METHODS OF PRESTO-B
A THREE-DIMENSIONAL, BWR CORE SIMULATION CODE
AMENDMENT 1
(NONPROPRIETARY VERSION)

RESPONSE TO NRC QUESTIONS

DECEMBER 1983

This amendment to Topical Report NF-1583.03, "Methods of PRESTO-B: A Three-Dimensional, BWR Core Simulation Code," is provided in response to requests for additional information as conveyed by Enclosure 2 of the letter to Mr. E. E. Utley, CP&L, from Domenic B. Vassallo, NRC Division of Licensing, dated November 1, 1983.

FIGURE 9.1

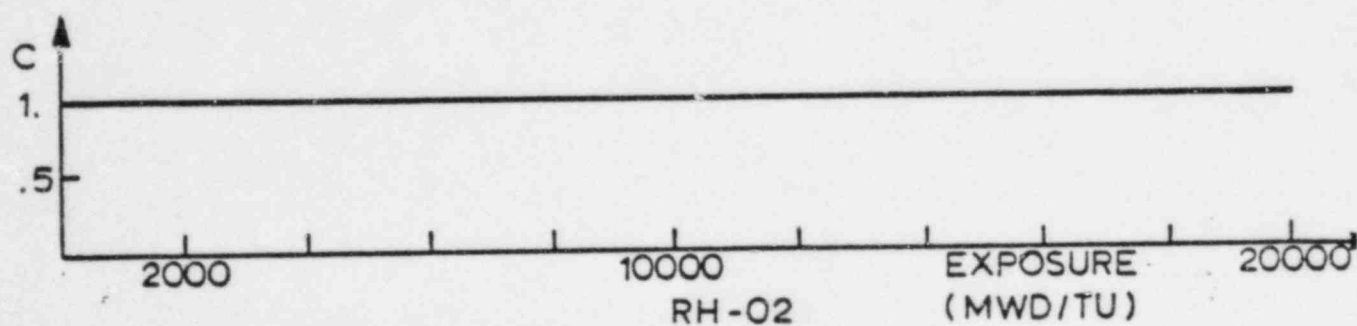
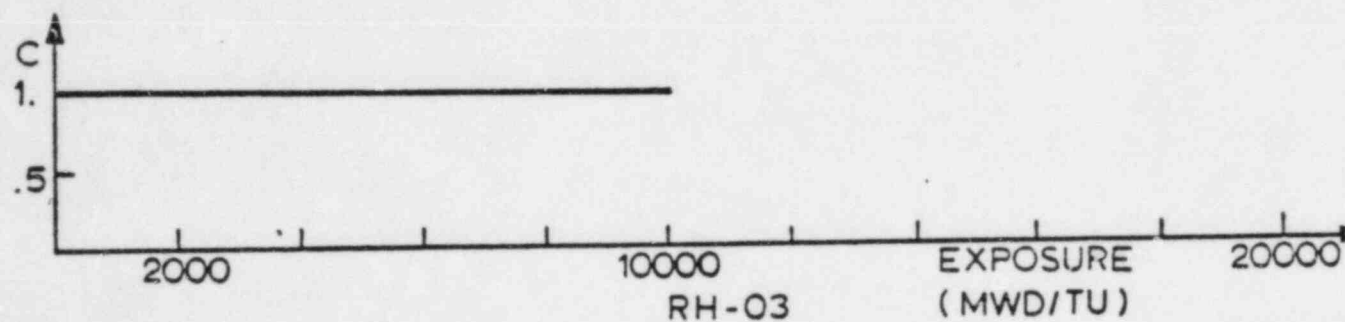
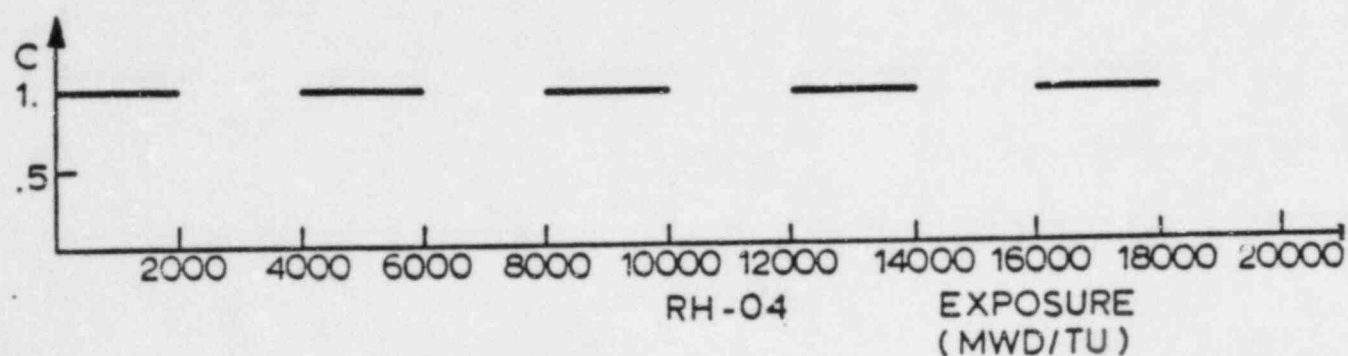
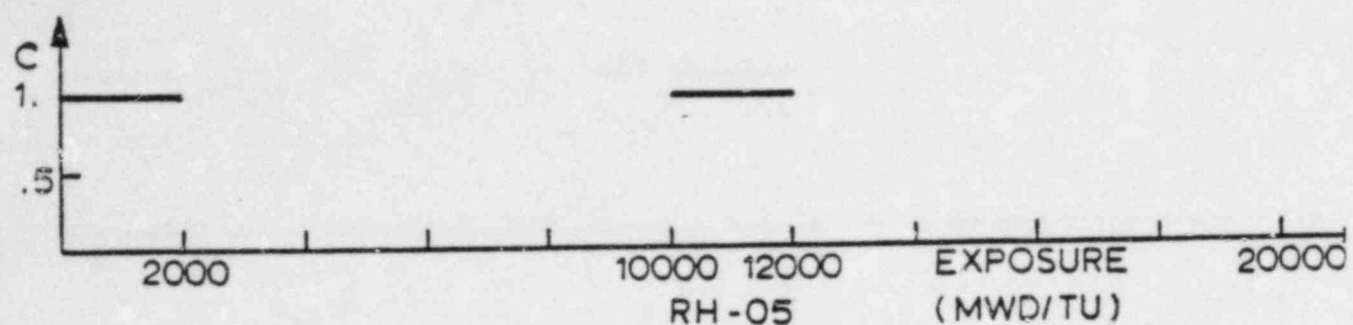
(Section 4.5.3)

Provide additional details of the model that describes control rod history effects on the two-group constants, including the explicit dependence of the group constants on the variables of interest.

Control rod history effects are modeled by correction terms $\Delta\lambda_2$ and $\Delta\nu\Sigma f_2$ to the corresponding nodal thermal group cross-sections. These correction terms are updated in each burnup step as follows:

a and b are fuel type dependent coefficients (separate constants for $\Delta\lambda_2$ and $\Delta\nu\Sigma f_2$) evaluated as illustrated in Fig. 9.1.

$\Delta\lambda(1)$ and $\Delta\lambda(3)$ are fuel type dependent constants evaluated from RECORD calculations with rodged depletion from zero to 10,000 MWD/T (Point 1) and unrodged depletion from 10,000 to 20,000 MWD/T (Point (1) to Point (3), Fig. 9.1).

FIGURE 11.1
DOPPLER TEMPERATURE VS.
LINEAR HEAT GENERATION RATE (LHGR)
*=T BEST EST. — =T PRESTO-B

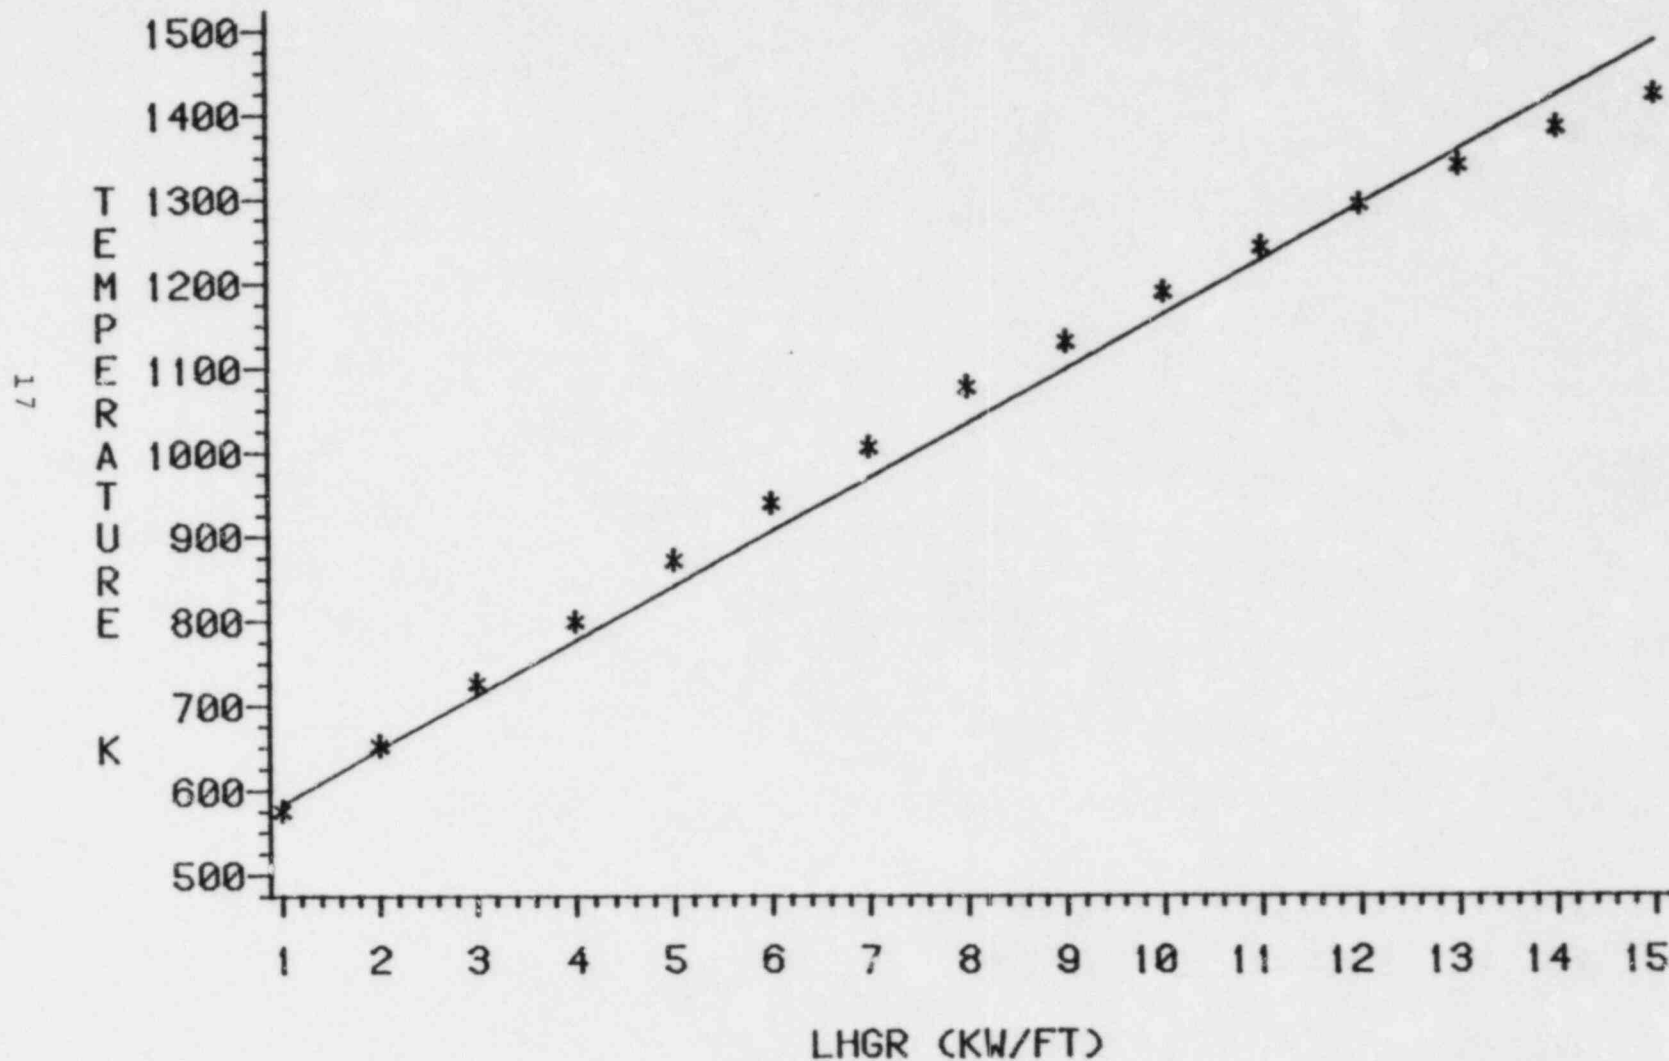
Provide the bases for the correlation between the effective Doppler temperature and the power density used in PRESTO-B.

Figure 11.1 compares the PRESTO-B and best estimate power to doppler fuel temperature relationship for a GE P8x8R lattice at 8 GWD/MTU. The power range of 1 to 15 KW/ft. spans conditions of normal operation and allows for 20% overpower on the peak core node, during a power transient. As can be seen, the linear power to temperature relation is sufficiently accurate to be used for steady state applications.

FIGURE 13.1

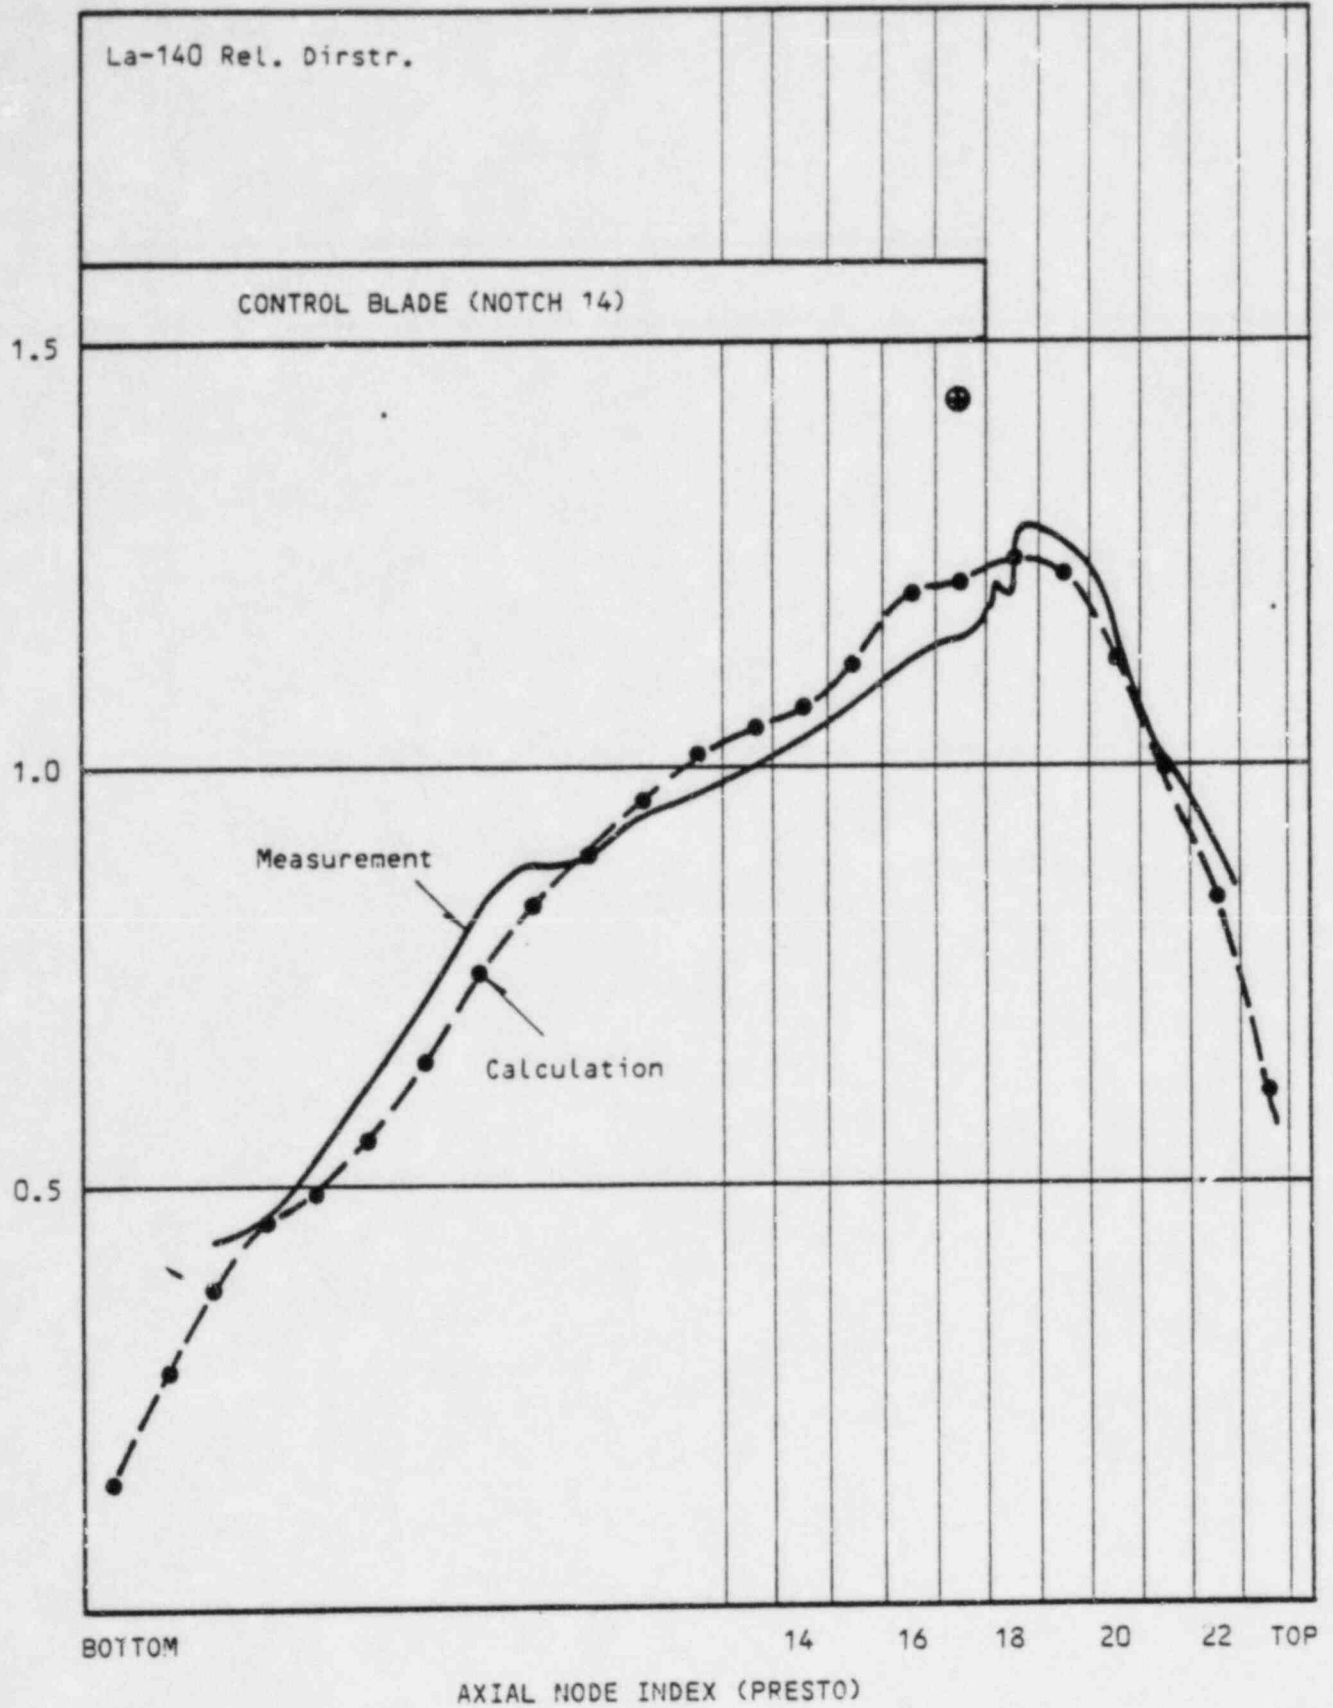
How is the formula used to account for 3-D effects near the tip of a control rod arrived at? What are the typical errors in eigenvalue and peaking factor introduced through its use?

This model has been evaluated by analysis of pin-wise gamma scan data (Hatch I) as illustrated in Figs. 13.1 and 13.2. Pins located in the N-N corner were chosen to represent typical peak locations for the roddeD condition. The calculated curves were obtained by multiplying the nodal La-140 distributions with N-N corner pin peaking factors evaluated by Eq. 7.5. Calculated points obtained without the correction formula (Eq. 7.6) are also shown for comparison. These are seen to produce pronounced, unrealistic spikes on the calculated curves.

Comparison of measured and calculated axial distributions of single pin La-140, Hatch I, HX373.

⊕ Denotes calculation without PRESTO control rod tip correction formula.
